File Number	PL 23-128	Contact	John Kelley, jkelly@duluthmn.gov	
Type	MU-I Planning Review	Planning Commission Date	September 12, 2023	
Deadline for Action	Application Date	July 11, 2023	60 Days	September 9, 2023
	Date Extension Letter Mailed	July 13, 2023	120 Days	November 8, 2023
Location of Subject	2101 Trinity Road – Southwest corner of existing building			
Applicant	Lake Superior College	Contact	Mark Cardinal	
Agent	Architecture Advantage	Contact	Shane Nies	
Legal Description	010-2710-06620			
Site Visit Date	September 1, 2023	Sign Notice Date	August 29, 2023	
Neighbor Letter Date	July 18, 2023	Number of Letters Sent	52

Proposal

Construction of 8,310 square foot building addition to house the Machine Tool and Welding programs as well as a loading and storage area. Additional site improvements include reconfiguring parking spaces and landscaping to facilitate the building addition.

PL 23-128
 MU-I Planning Review
 Site Map

UDC LANDSCAPE PLAN

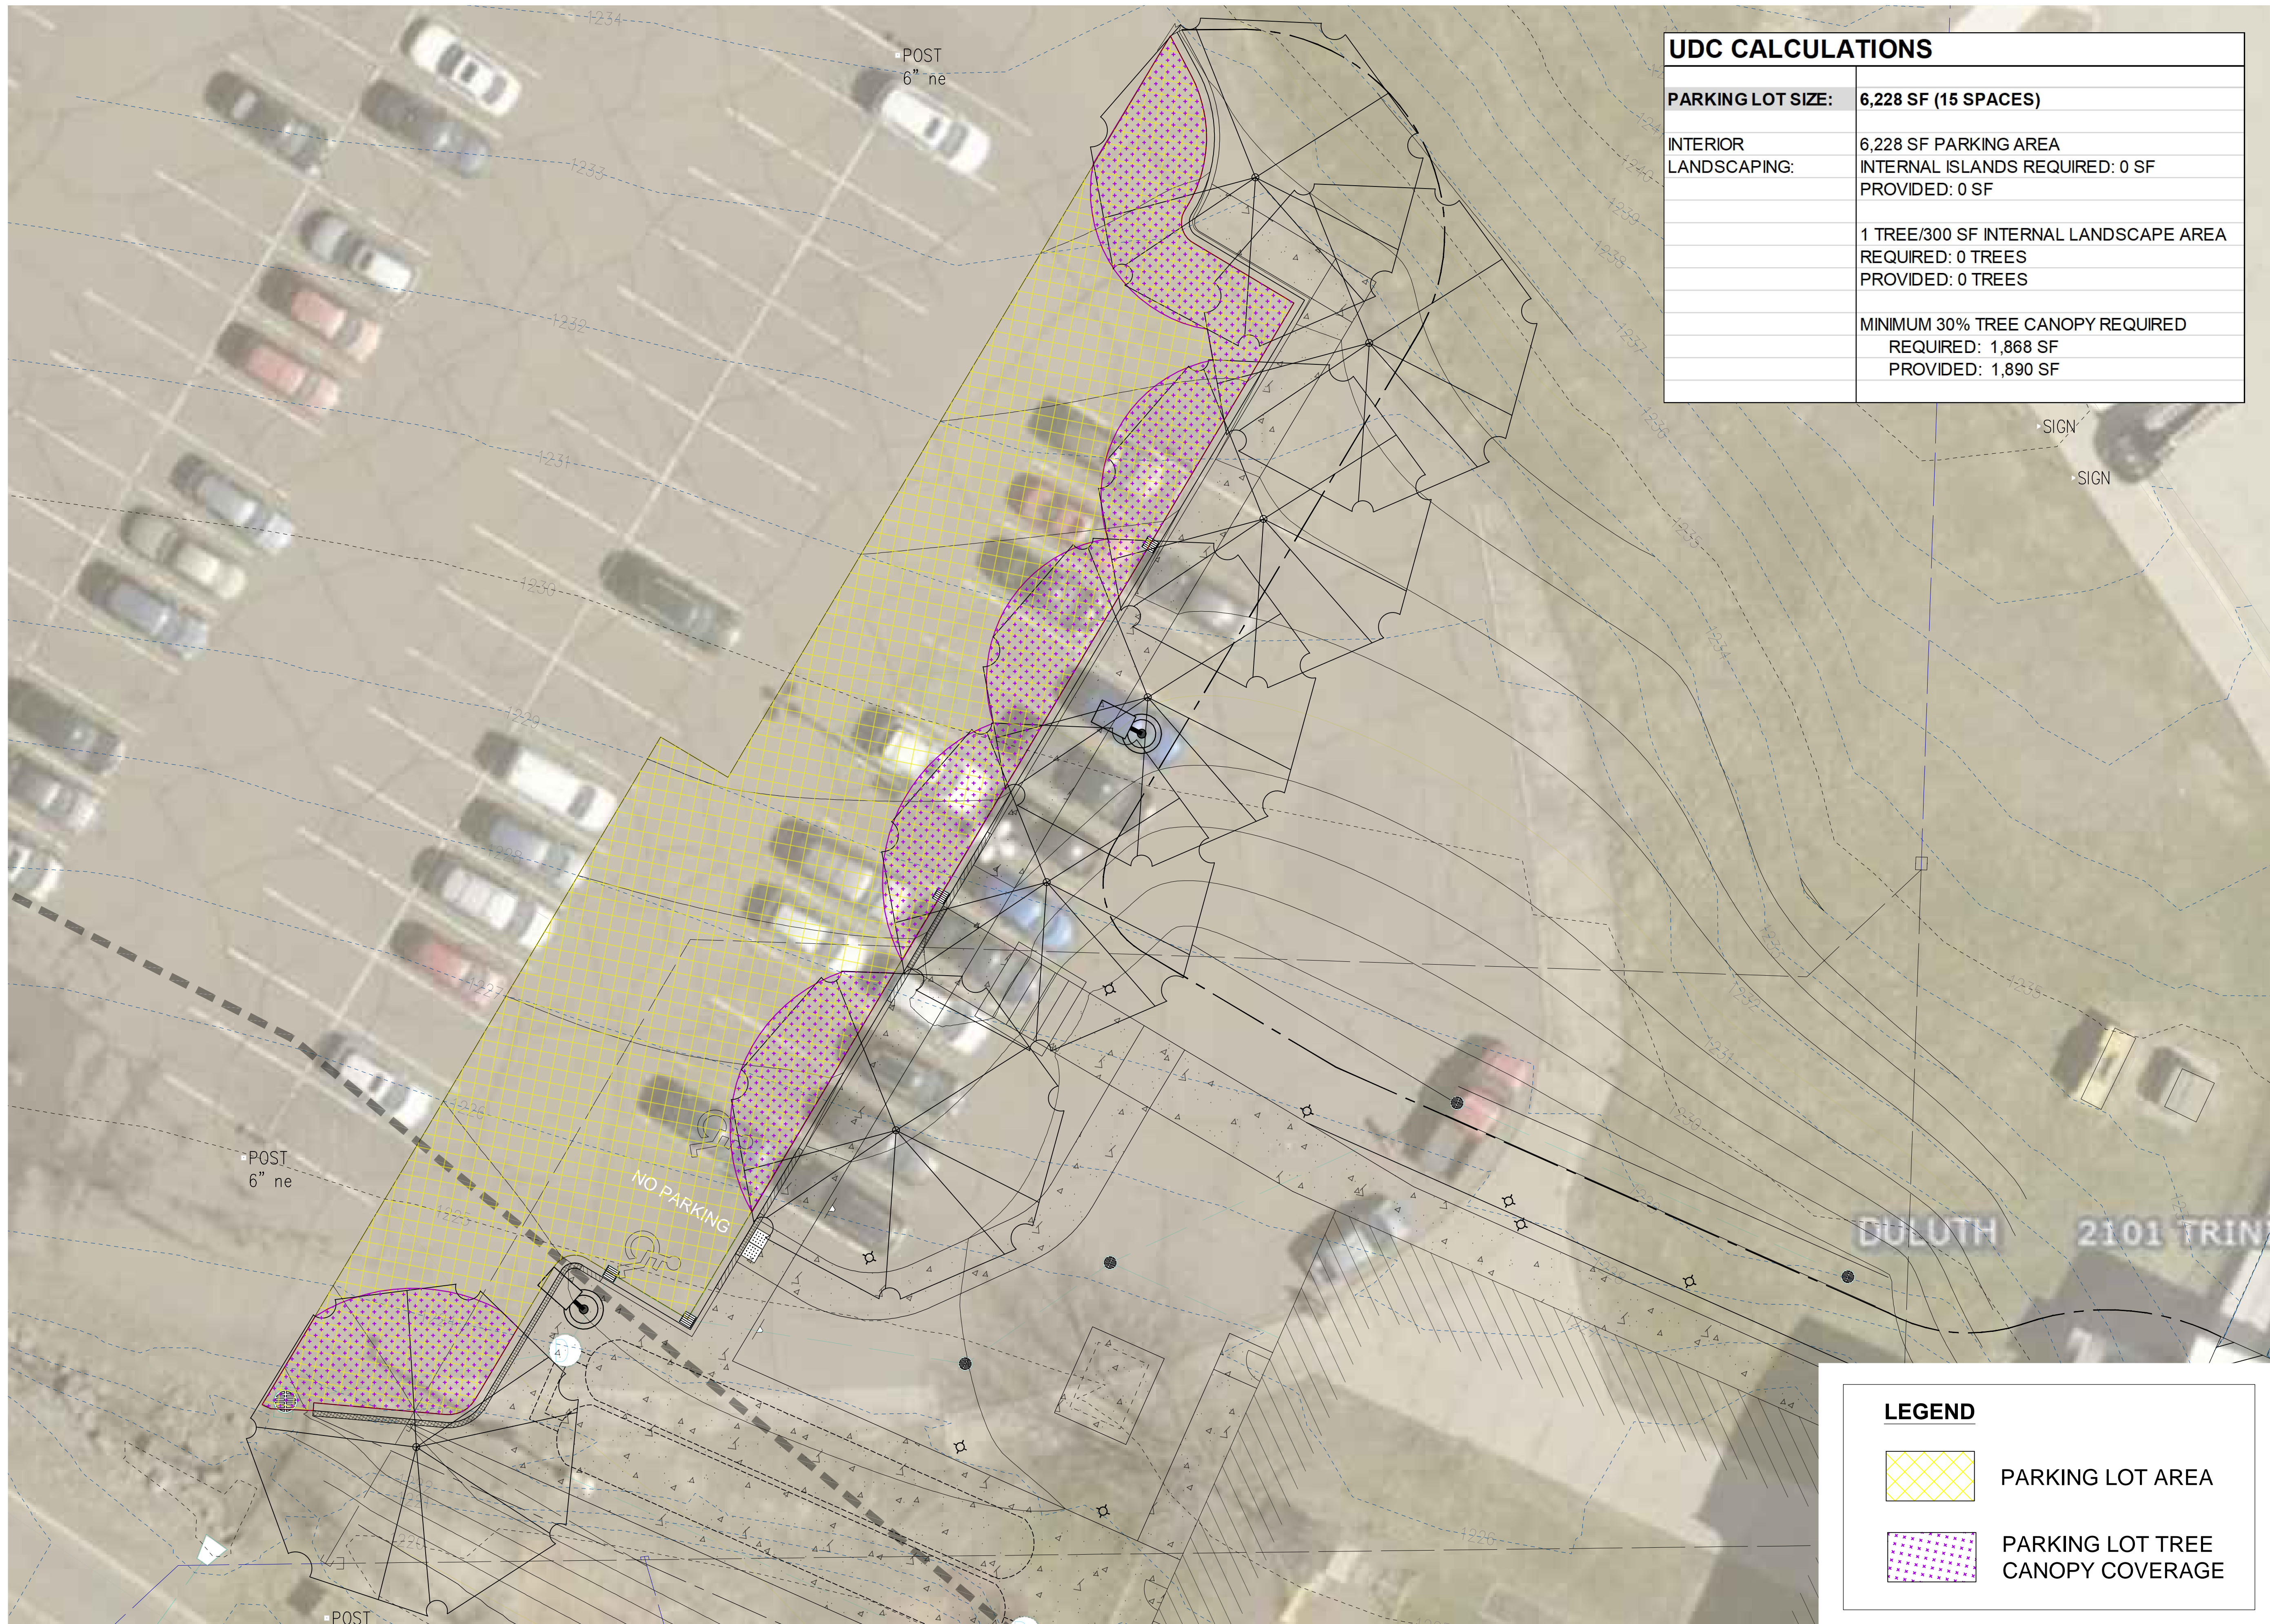
4. Proposed improvements do not trigger any UDC requirements related to landscaping, sustainability or building design standards. However, the new parking area with less than 25 parking spaces must provide the minimum tree canopy of 30 percent at maturity. The attached landscaping plan does include shrubs in the area between the building addition and the parking lot, and trees on either side of the building addition and along the front edge of the new parking spaces but did not include a canopy coverage calculation. The applicant did provide an updated tree planting plan meeting the 30 percent canopy coverage for the parking spaces. Staff is recommending the applicant provide an updated landscaping plan incorporating the 30 percent tree canopy coverage plan.

1. Applicant shall construct and maintain the project as identified in the attached exhibits.
2. Applicant shall submit a revised landscaping plan incorporating the 30 percent tree canopy coverage plan.
3. Applicant shall submit a lighting plan meeting the UDC lighting standards at the time of building permit submittal.
4. Any alterations to the approved plans that do not alter major elements of the plan may be approved by the Land Use Supervisor without further Planning Commission approval; however, no such administrative approval shall constitute a variance from the provisions of Chapter 50.

PARKING LOT SIZE:	6,228 SF (15 SPACES)
INTERIOR LANDSCAPING:	6,228 SF PARKING AREA INTERNAL ISLANDS REQUIRED: 0 SF PROVIDED: 0 SF
	1 TREE/300 SF INTERNAL LANDSCAPE AREA REQUIRED: 0 TREES PROVIDED: 0 TREES
	MINIMUM 30% TREE CANOPY REQUIRED REQUIRED: 1,868 SF PROVIDED: 1,890 SF
